#### PREPARED FOR THE LANDMARKS COMMISSION

Project Name/Address: 711-715 Orton Court

**Application Type:** Certificate of Appropriateness for exterior alteration in historic district

Legistar File ID # 51435

Google street view image

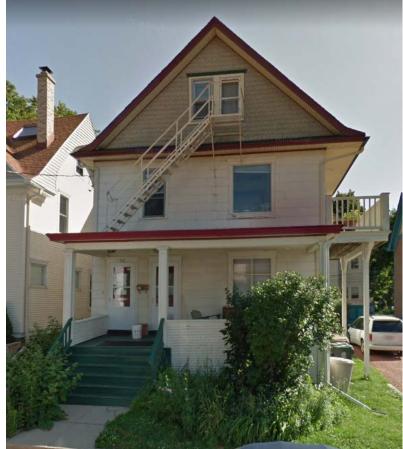
The Applicant is proposing to remove the existing transite siding and original cedar siding and install new Hardieplank siding without wood grain at the first and second floors. The new siding will die into corner boards at the building corners and terminate at the soffit behind a 1x trim piece. The window and door trim will also be removed and replaced with new Hardieplank material at the first and second floors. Some soffit repair is needed and will be completed with in-kind materials. The front porch will remain as it exists. The front gable wall also remain as it exists.

- a) The landscape treatment and the rhythm of masses and spaces are not being affected by the proposal.
- b) The historical proportion and rhythm of solids to voids are not changing.
- c) The Hardieplank siding material will provide an appearance that is more historical than the existing transite siding; however, the original cedar siding shows a narrow exposure of 2 ½" and the Hardieplank exposure is proposed to be 4". The siding on the front porch appears to be 2 ½" exposure and is not changing.
- d) The roof is not being altered by this proposed work.
- e) See comment b above.

- 1. The windows and doors have a decorative head trim and it appears that the jamb trim dimension is slightly narrower than the head trim dimension. The approved work shall involve the replication of the existing decorative head trim and dimensions of the flat jamb and head trim.
- 2. The jamb trim shall die into the top of a projecting show sill to exactly replicate the existing appearance. The window trim shall not be "picture framed".
- 3. The Landmarks Commission shall provide the applicant with the specific siding exposure dimension that would be appropriate for this building.
- 4. The Hardieplank siding shall be smooth without wood grain.
